## Product Change Notification / ASER-28RAPG851

CCB 5128 Final Notice: Qualification of a new lead frame design and G700 as a new mold compound material for selected MIC277xxx device family available in 5L SOT-23 package assembled at STAR assembly site.

**PCN #: ASER-28RAPG851**

# Lead Frame Design Comparison

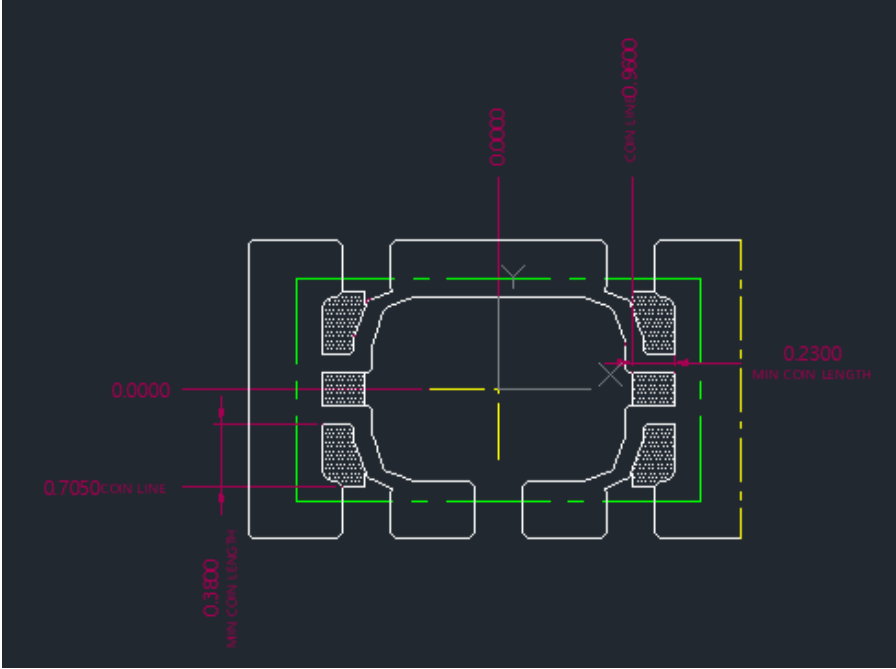
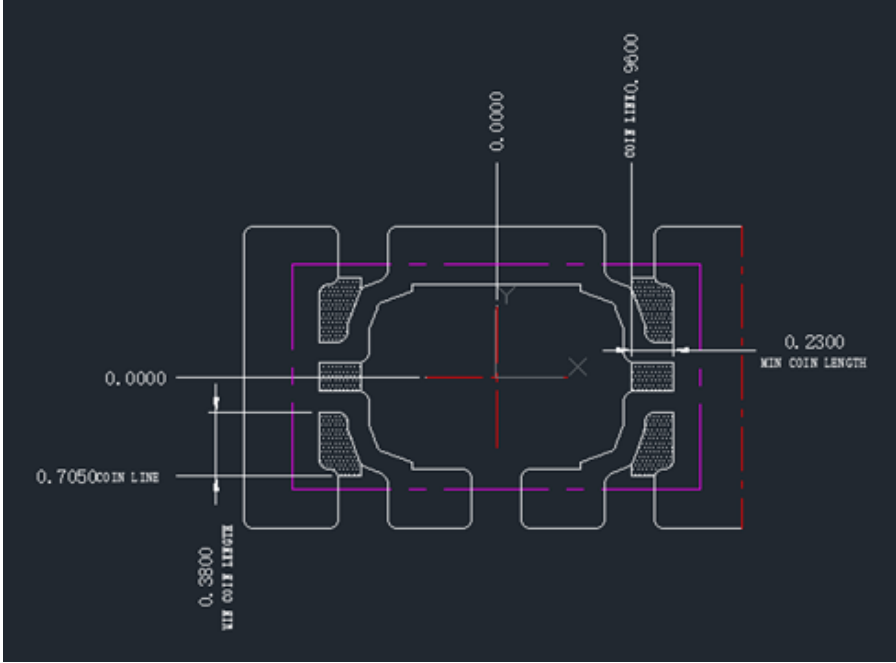
| Pre Change                                                                          |                       | Post Change                                                                          |                         |
|-------------------------------------------------------------------------------------|-----------------------|--------------------------------------------------------------------------------------|-------------------------|
| C194                                                                                | NiPdAu with Roughened | C194                                                                                 | NiPdAuAg with Roughened |
